# UNITED STATES PATENT AND TRADEMARK OFFICE

APPLICATION NO.	FILING DATE	FIRST NAMED INVENTOR	ATTORNEY DOCKET NO.	CONFIRMATION NO.
10/071,726	02/08/2002	Jeffrey R. Moritz	P00548-US-1 (14913.0020)	3222
28078	7590	10/27/2005		EXAMINER GORDON, BRIAN R
MAGINOT, MOORE & BECK BANK ONE CENTER/TOWER 1111 MONUMENT CIRCLE INDIANAPOLIS, IN 46204			ART UNIT 1743	PAPER NUMBER

<b>Office Action Summary</b>	Application No.	Applicant(s)
	10/071,726	MORITZ ET AL.
	Examiner	Art Unit
	Brian R. Gordon	1743

**DETAILED ACTION**

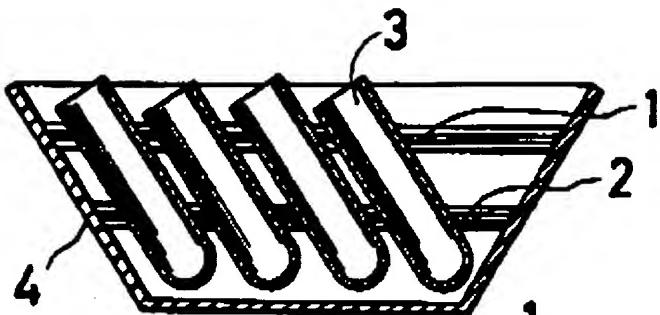
The tube holder is preferably constituted by upper panel 1 (face having a plurality of seats) and lower panel 2 which have means to hold each tube in the usual manner and which can be slid horizontally. (column 1, lines 40-42).

Variable angle tube holder used in this invention may be made of glass, metals, plastics **or composite of these materials**. The upper and lower panels may be a plate with holes which can hold tubes, or a composite of wires or sticks. (column 2, lines 40-44)

As seen in the figure above sidewall (4) depends downward from face 1.

Iizuka et al does not specifically describe the holder as being comprised of an electrically conductive plastic.

It would have been obvious to one of ordinary skill in the art at the time of the invention recognize that the plastic material of Iizuka may be substituted with the

polypropylene carbon filled material as taught by Mehra in order to produce an economical rack capable of holding pipette tips.

The carbon filled polypropylene is the same material as disclosed by applicant as such the material inherently has the same properties and is considered to be an electrically conductive plastic material.
